Access Compliance Report

Public Rights-of-Way

(Curb Ramps)

Intersection ID: 52299	Main Street: LAKE_VISTA_LN	Cross Street: LINDA_VISTA_LN	Location: W
ADA ID: 85082618896A	Ramp Type: PerpDiag	Initial Pass/Fail: Fail	Overall Compliance: No
Severity Score: 21.25			
Codes/Mitigation Info/Possible Solution		Field Measurements/Component Compliance

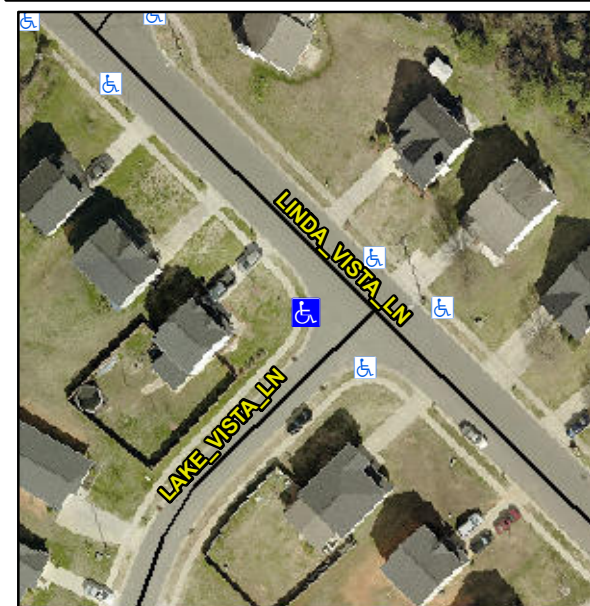
Not Found, R304.5.1, R304.2.2

Compliance	Description	Data	Compliance	Description	Data
N/A	Ramp Length (in)	52.0	No	Ramp Slope (%)	11.1
No	Ramp Width (in)	45.0	Yes	Ramp XSlope (%)	1.9
N/A	Flare Type LT	N/A	N/A	Flare Type RT	N/A
N/A	Flare Slope LT (%)	N/A	N/A	Flare Slope RT (%)	N/A
N/A	Flare Traversable LT?	N/A	N/A	Flare Traversable RT?	N/A
N/A	Landing Length (in)	N/A	N/A	DWS Provided?	N/A
N/A	Landing Width (in)	N/A	N/A	DWS Contrast?	N/A
N/A	Landing Slope (%)	N/A	N/A	DWS Length (in)	N/A
N/A	Landing X Slope (%)	N/A	N/A	DWS Full Width?	N/A
N/A	Landing Curb? (Y/N)	N/A	N/A	DWS Offset (in)	N/A
N/A	Shared Landing?	N/A			
N/A	Gutter Ponding?	N/A	N/A	Gutter Slope (%)	N/A
N/A	Gutter Lip Ht (in)	N/A	N/A	Gutter X Slope (%)	N/A
N/A	Painted X Walk1?	No	N/A	Painted X Walk2?	No
	X Walk 1 Direction	To SE		X Walk 2 Direction	To NE
N/A	X Walk 1 Width (in)	N/A	N/A	X Walk 2 Width (in)	N/A
	X Walk 1 Slope (%)	2.0		X Walk 2 Slope (%)	0.9
	X Walk 1 X Slope (%)	0.7		X Walk 2 X Slope (%)	2.0

Remove & Replace Curb Ramp With Two New Directional Ramps or Equivalent.
